## DEVELOPMENT APPLICATION ASSESSMENT REPORT

<b>Application Number:</b>	DA2024/1079
<b>Responsible Officer:</b>	Sonya Constantinou – Consultant Planner (Creative Planning Solutions) – External Assessment
<b>Land to be developed (Address):</b>	53, 53A & 53B Warriewood Road, WARRIEWOOD NSW 2102
<b>Proposed Development:</b>	Subdivision - Community title subdivision and civil works
<b>Zoning:</b>	Pittwater Local Environmental Plan 2014 – R3 Medium Density Residential
<b>Development Permissible:</b>	Yes
<b>Existing Use Rights:</b>	N/A
<b>Consent Authority:</b>	Northern Beaches Council
<b>Determination Level:</b>	Northern Beaches Local Planning Panel
<b>Land and Environment Court Action:</b>	N/A
<b>Owner:</b>	Northern Beaches Council (53 Warriewood Road) Sekisui House Services (NSW) Pty Limited (53A & 53B Warriewood Road)
<b>Applicant:</b>	Sekisui House Services (NSW) Pty Limited
<b>Application Lodged:</b>	26/08/2024
<b>Integrated Development:</b>	Yes – NSW Rural Fire Service and Department of Planning and Environment – Water

Development Application DA2024/1079 (referred to herein as the DA or DA2024/1079) seeks consent for community title subdivision into five (5) super lots, the subd

Figure 5 Location of sewer easement highlighted shaded in blue upon the subdivision plan.

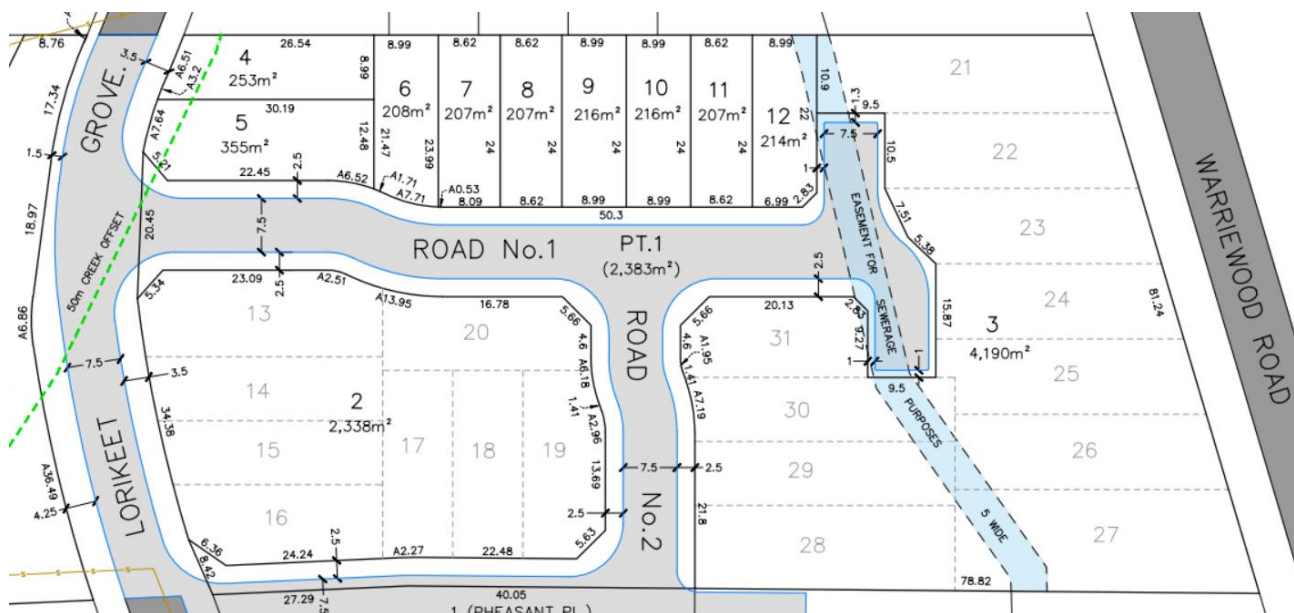
A sewer easement 5m wide runs east to west across the subject site as marked within the figures below (Figure 5 and Figure 6). This easement is identified in the Second Schedule of the Title for Lots 2 and 3 in DP 1115877. As this easement has been imposed by Council the provisions provided under clause 1.9A do not benefit the applicant. Accordingly, no buildings (with the exception of the roadway) are permitted over this portion of the land, and this has been conditioned within the notice of determination.

Figure 8: Urban Release Area Map -Sheet URA\_012. Site marked by green outline.

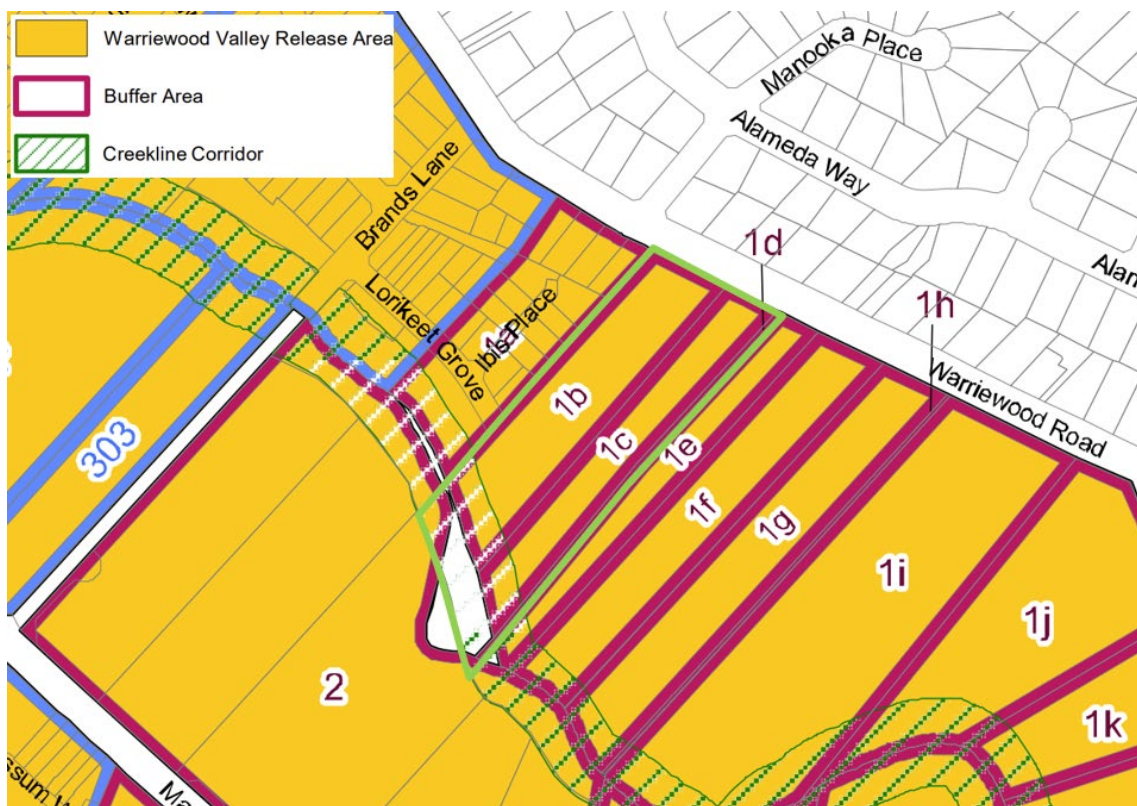
The site is mapped upon the Urban Release Area Map -Sheet URA\_012 under PLEP within buffer area 1b, 1c and 1d (Figure 8). Clause 6.1(3) requires that the total number of dwellings shown opposite that buffer area, sector or address in Column 2 of that table will be erected.

Specifically, the Urban Release Area Map -Sheet URA\_012 identifies a minimum of 17 dwellings or a maximum of 24 dwellings would be required for 53A Warriewood Road, a minimum of 13 dwellings or a maximum of 18 would be required for 53B Warriewood Road and a minimum of 1 dwelling be provided for 53 Warriewood Road.

The development will allow for a minimum of 31 dwellings to be provided for the land and demonstrates compliance with clause 6.1(3) of PLEP 2014.

Figure 9 Lots 6 – 12 within Stage 1 of the subdivision.

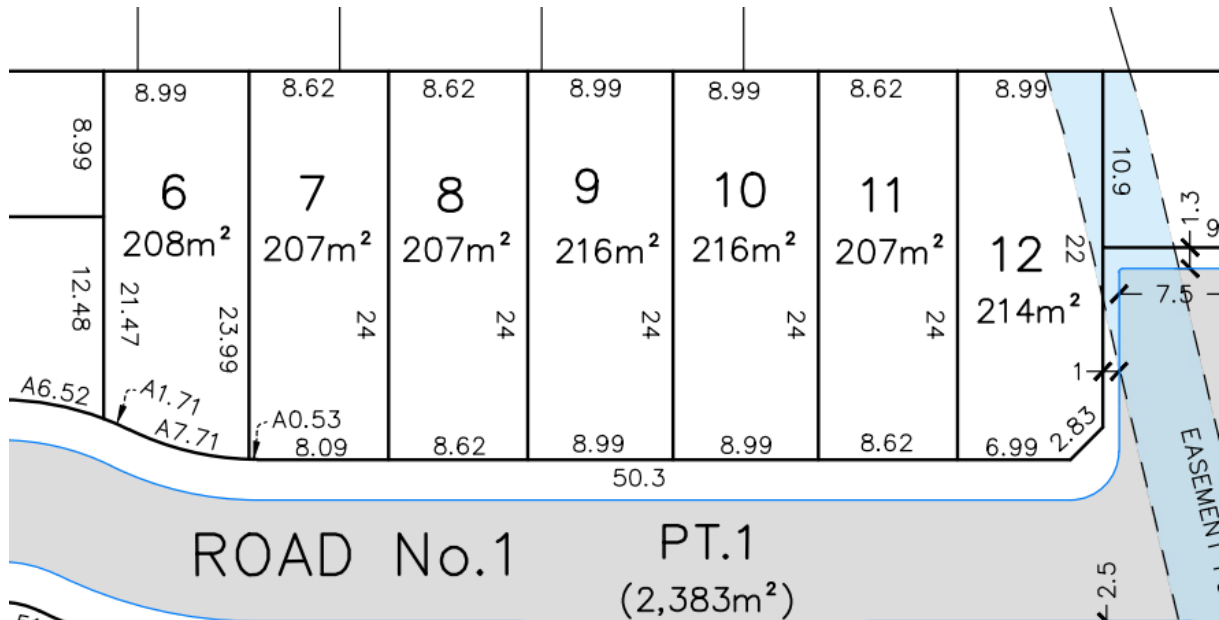
The proposal includes the creation of seven allotments identified as Lots 6 – 12 which have an area less than 225m<sup>2</sup> and a width less than 9m. The dimensions of the lots are detailed as follows and illustrated in Figure 9:

The building envelopes provided with the DA demonstrate that the future dwellings on these lots will achieve the minimum requirements for landscaped areas, private open space, and deep soil zones. This ensures that even with a lot width less than 9 metres, the future development will retain a high level of amenity by efficiently utilising the available space within the approved envelopes. Furthermore, the northern orientation of these allotments will ensure the resultant dwellings achieve more than the minimum solar access to the principal living areas and private open space, as required by the DCP.

While the DA does not include internal floor plans for Lots 6 to 12, the building envelope plans will form part of the consent and will be registered on the Section 88B Instrument. The registration of the building envelope plans on the Section 88B Instrument provides a mechanism to ensure the development outcome will achieve compliance with clause 6.1 of PLEP and ensures the development is consistent with the desired character of the locality.
